Response to the Reviewers' Comments

The authors would like to thank the reviewers for the precious comments and suggestions on the technical contents and presentation of our manuscript “Runtime Power Management of Battery Electric Vehicles for Extended Range with Consideration of Driving Time,” submitted to IEEE Transactions on Very Large Scale Integration (TVLSI.) This revised manuscript has been greatly improved thanks to the reviewers' invaluable advices. We have revised the manuscript faithfully following the reviewers's comments. We include the newly added or significantly modified parts in the revised version of the paper also in Response to Reviewers. We highlight the important technical content changes and set those parts in a red color in the revised paper.

Fig. 2: (a) Range-speed experimental data for Chevrolet Bolt [36] and (b) comparison with simulation results of the proposed EV power model.

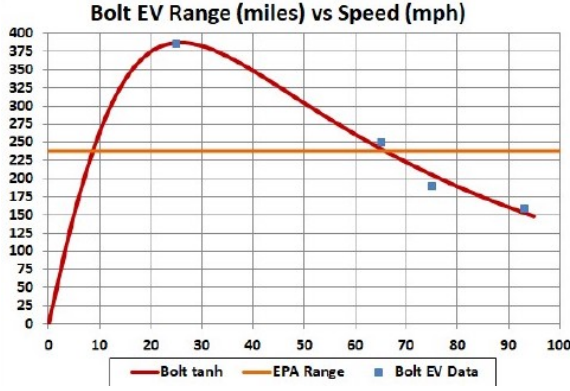
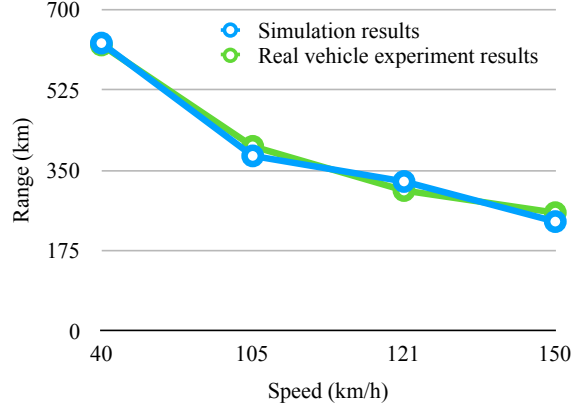
R1-C2 It is not clear how to validate the power model of EV. As the author mentions that accuracy of power model is quite important, it is good to see the power model in this paper can be validated by some real measurement results.

We further evaluate the model accuracy with the range-speed real vehicle experiments as shown in Fig. 2(a) to confirm the derived power models are close enough to the real vehicle measurement data [32], [33], [34], [35], [36]. We refine the coefficients until all the available data values match well.

As a result, the derived EV power model well matches with the range-speed experimental data as shown in Fig. 2(b) as well as the top speed and maximum acceleration setting the aerodynamic resistance, rolling resistance, curb weight, etc. with the known values. The errors in the range-speed simulation is merely 1.4%, the time for 0-to-100 km/h error is 7.8%, and the top speed error is 3.0%, respectively.

Fig. 12: Velocity profile comparison with EDP , E^2DP and E^3DP on Jones Street in San Francisco.

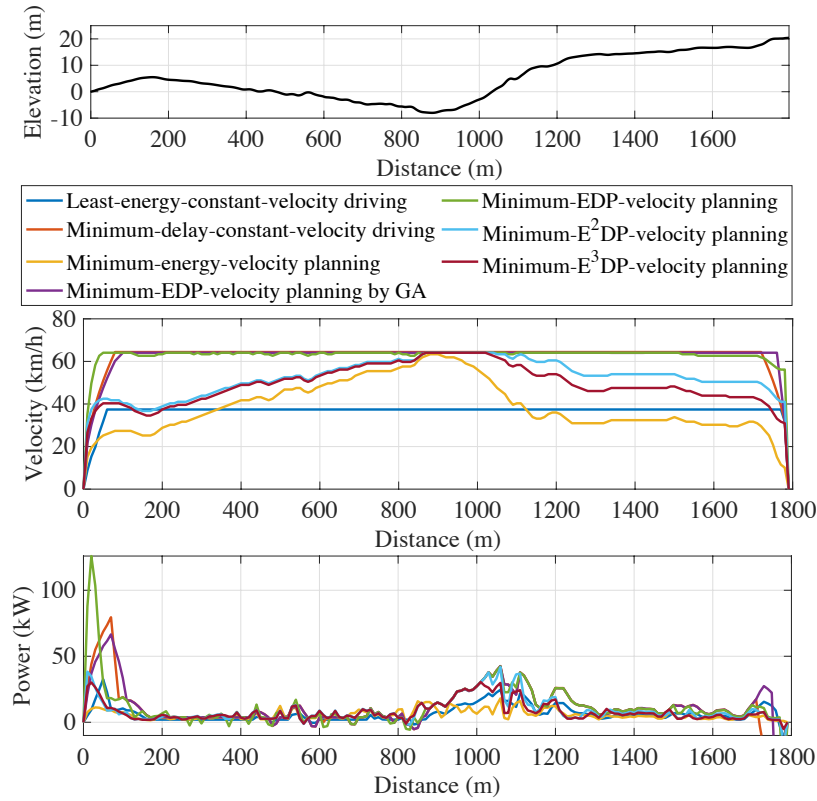
R1-C3 The optimality of the proposed scheduling algorithm is unclear. The author should add several paragraphs to discuss this topic. It is also to see the comparison baseline is well accepted to show the advantage of the proposed algorithm.

Fig. 12 summarizes EDP of the least-energy-constant-velocity driving, the minimum-delay-constant-velocity driving, the minimum-energy-velocity planning, the velocity planning with EDP , E^2DP and E^3DP as a metric on the road benchmarks and the minimum- EDP -velocity planning with GA. The proposed velocity planning results in up to 46.2% improvements of EDP compared with the least-energy-constant-velocity driving. The driving velocity on a flat road is faster than that of the least-energy-constant-velocity driving at the expense of relatively little energy to save driving time. Then, the velocity decreases when climbing the following uphill to spend less motor torque, which saves more energy.

We also updated Fig. 12 and Fig. 13:

Fig. 11: Histograms of velocity and acceleration for the proposed energy-aware-velocity planning methods without an acceleration constraint (a) and (b) and with an acceleration constraint (c) and (d), respectively.

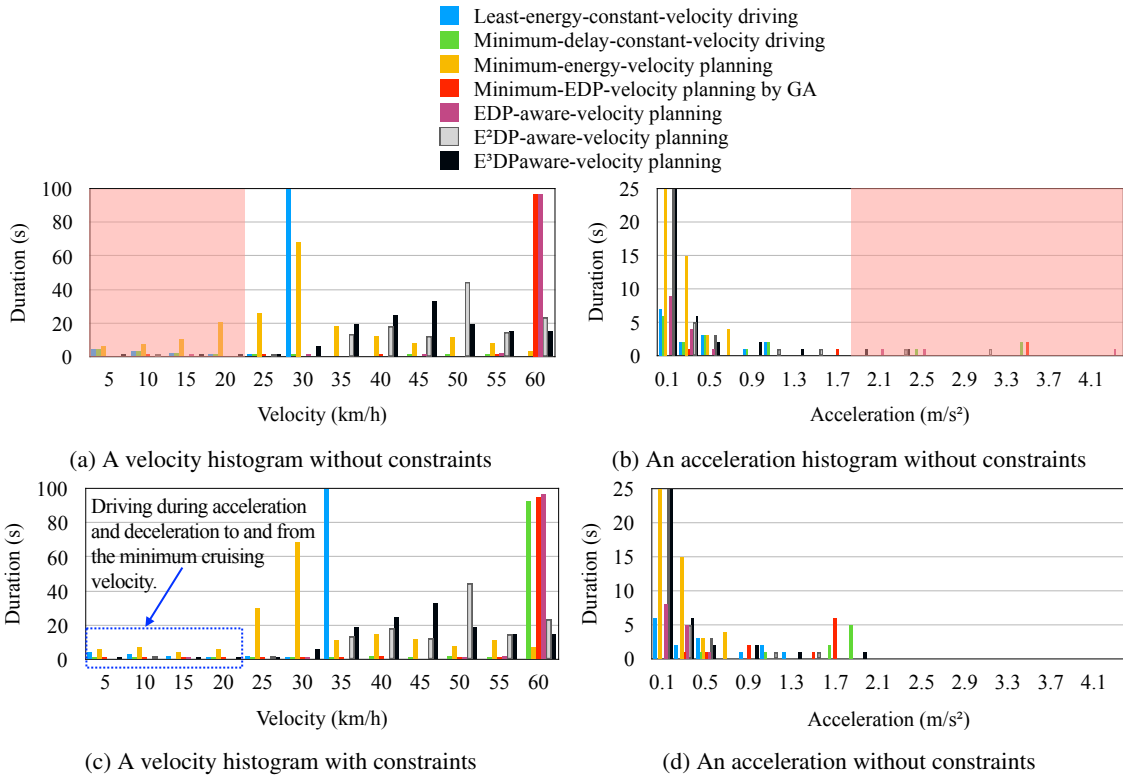
R2-C2 It would be good to have more discussion on the assumptions of the approach and the experiments, e.g., how much can the velocity be changed in practical scenarios without impeding traffic and causing unsafe situations (also depending on the road conditions and whether it is urban or rural environment I suppose). Currently, there only seems to be one constraint on not slower than 10 km/h.

Fig. 11(a) and (b) show two histograms of the driving schemes in Fig. 12, which do not have velocity and acceleration constraints. We avoid a cruising velocity lower than 25 km/h and an acceleration higher than 2.0 m/s^2 in this paper without loss of generality. The acceleration of 2.0 m/s^2 is the same as the maximum acceleration of compact cars designed to be used primarily used in urban areas (13 seconds of 0 to 100 km/h time).

Fig. 11(c) and (d) shows the velocity and acceleration histograms with the constraints. Once we run the DP for the first time without constraints, we analyze the histogram, adaptively determine the minimum cruising velocity and maximum acceleration constraints, and run DP again. We keep the same constraints for online recomputation whenever unexpected interrupts occurs.

We also enforce the minimum acceleration not lower than 1.0 m/s^2 when the EV starts from a stop sign or a traffic light until the velocity reaches to the minimum cruising velocity not to bother traffic flow. The acceleration of a 1.0 m/s^2 exhibits 6 second delay to reach 25 km/h. The maximum speed is bounded by the speed limit of each road benchmark.

Fig. 8: Benchmark altitude.

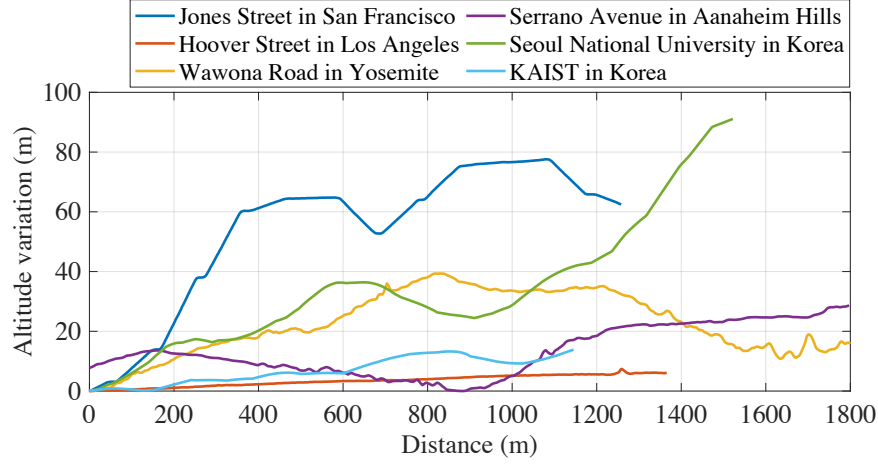
R2-C3 Related to the last point, it would be good to have more discussion on the road benchmarks, e.g., how they are generated and how representative they are. The optimization results significantly depend on road slope. It would be good to use a variety of real road segments for testing.

R2-A3 We appreciate the reviewer's comment and added six new real routes from various locations in California. The first three roads are in cities. Jones Street in San Francisco and Hoover Street in Los Angeles are two representative city landscapes such as hills and flat roads, respectively, and Cliff Drive in Santa Barbara is a mixture of those. The second two roads are in mountain areas: Serrano Avenue in Anaheim Hills and Otay Lakes Road in San Ysidro Mountain in California. The last road is Junipero Serra Boulevard connecting San Francisco and San Jose. The details of road data is summarized in Table II, and Fig. 8, which visualize the altitudes of the road benchmarks.
